DMVA Project #: 42170088 New Range Tower Range 6 and Range 10 Fort Indiantown Gap Annville, PA 17003

# ADDENDUM #001 Responses to Contractor Bid Based RFIs

**SK-01**

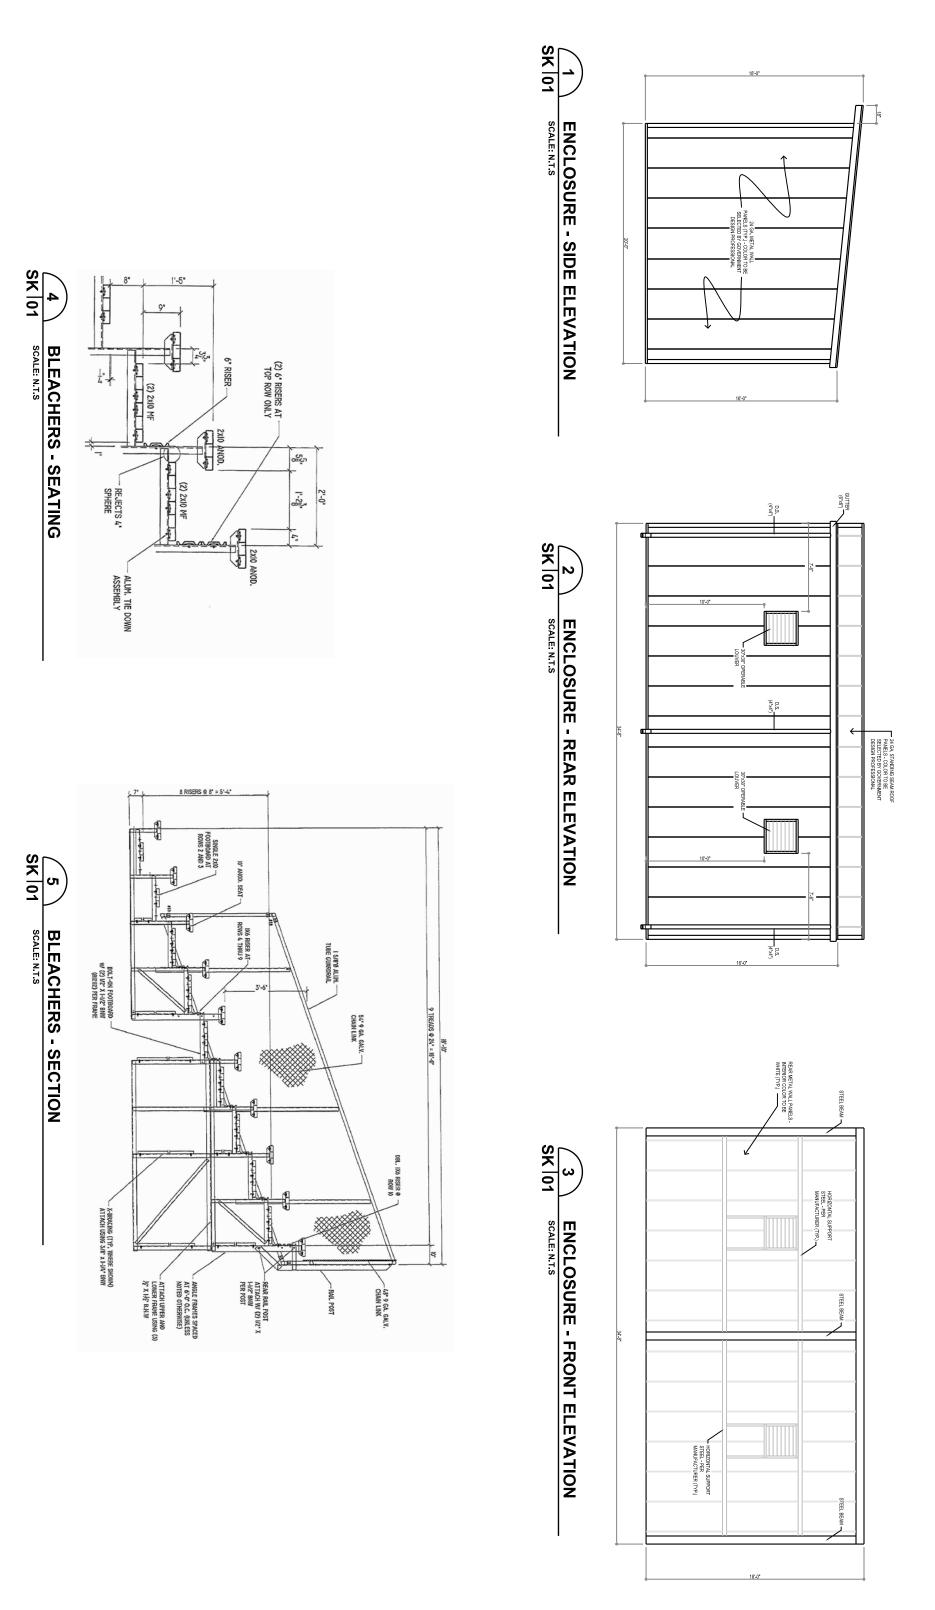
- Q For the Bleachers, the only information listed is that on Drawing A.1.2. Are there specifications or designs other than what is listed on the drawing?
- A Please see attached sketches for more information regarding the bleacher enclosures.
- Q Are there any specifications regarding the windows and associated glazing?
- A See attached specifications for Glazing requirements.
- Q Can the FSC certification be waived for trusses? Do they need to be pressure treated?
- A FSC Certification is not needed. Trusses do not need to be pressure treated.
- Q -Plans show 4" fabric wrapped drain tile. Where is this to be terminated?
- A Drain tile is not needed.
- Q Regarding seeding, is only the disturbed areas to be seeded?
- A Yes.
- Q Can you please provide a Door Hardware Schedule?
- A See attached specifications.
